TECHNICAL BULLETIN

Contact: For further assistance, call ETI Technical Service at 1-863-701-0096 and refer to Tech Bulletin #012717.

Figure 1. Initial Charge of PSC System

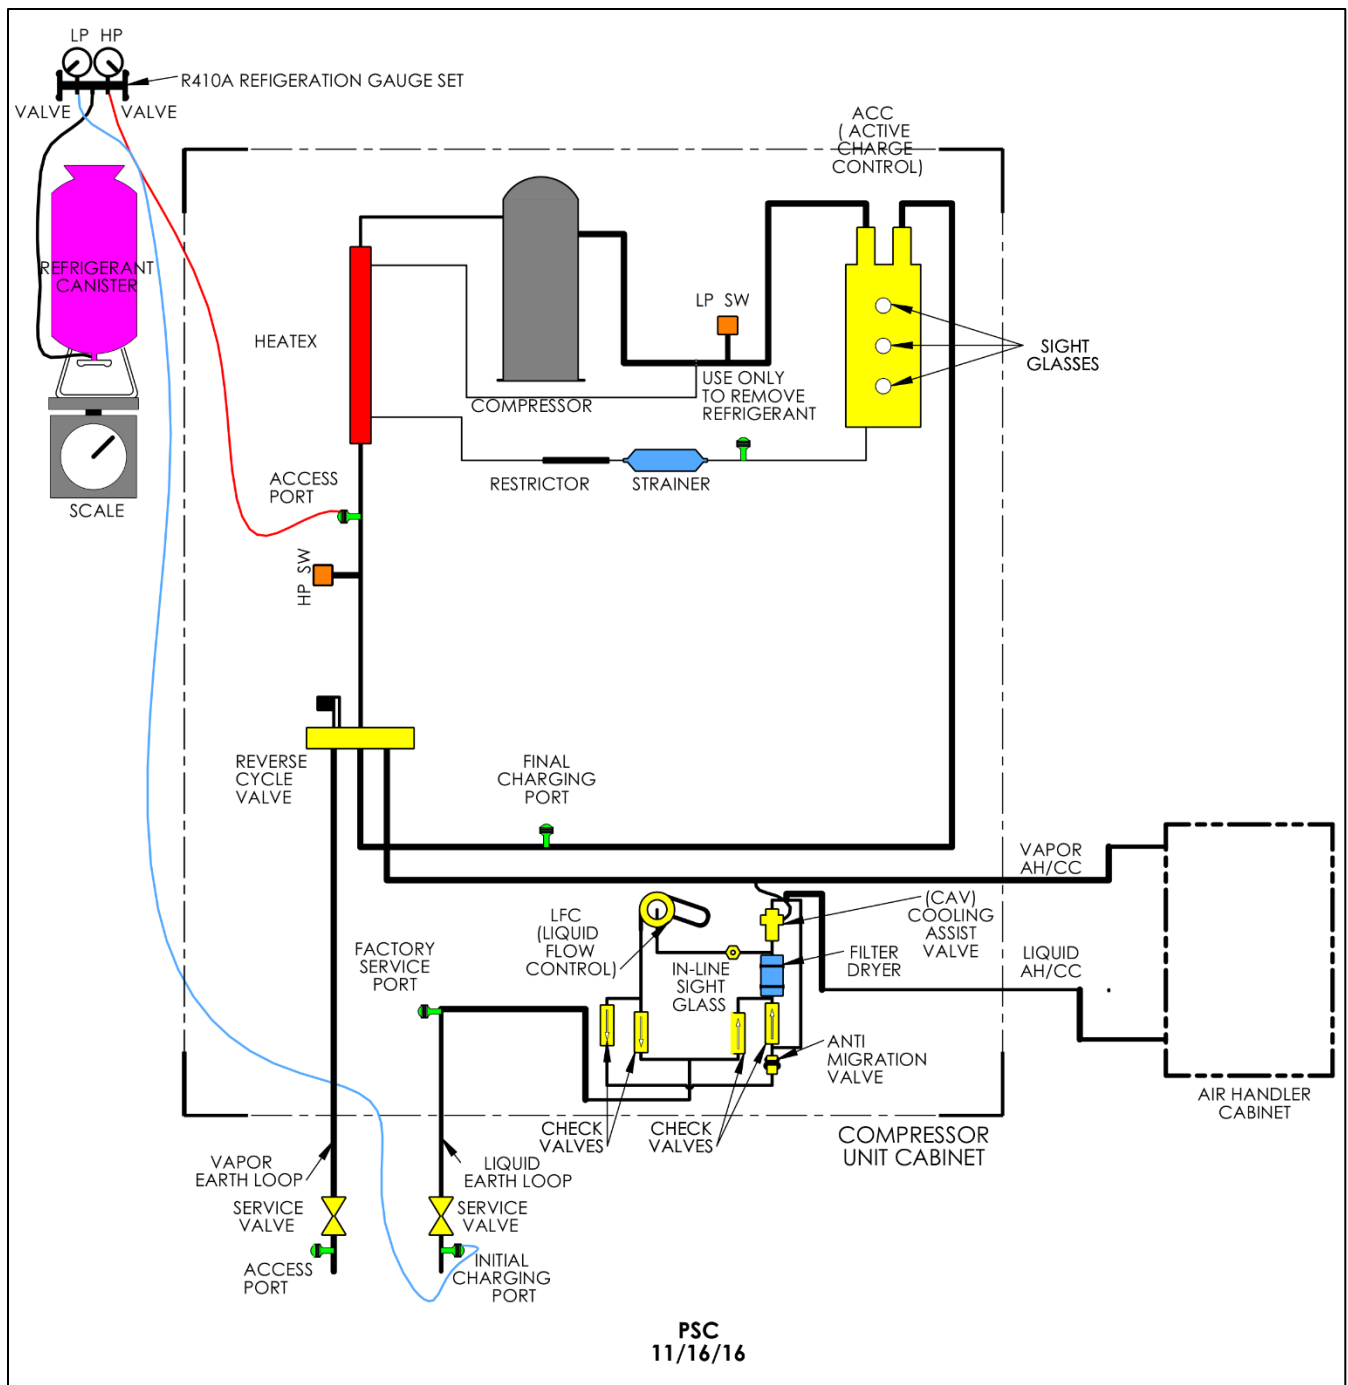
The PSC and PSD quick-start manuals, active between March 2016 and December 2016, have been featuring the incorrect rail in the drawings. The internal flow schematics and piping diagrams were based on the Classic Series rail instead of on the Prime Series rail. As a result, the Initial Charging Port was shown in the incorrect place. Drawings have been corrected in the latest manuals, published at the end of December 2016.

The corrected drawings are shown below.
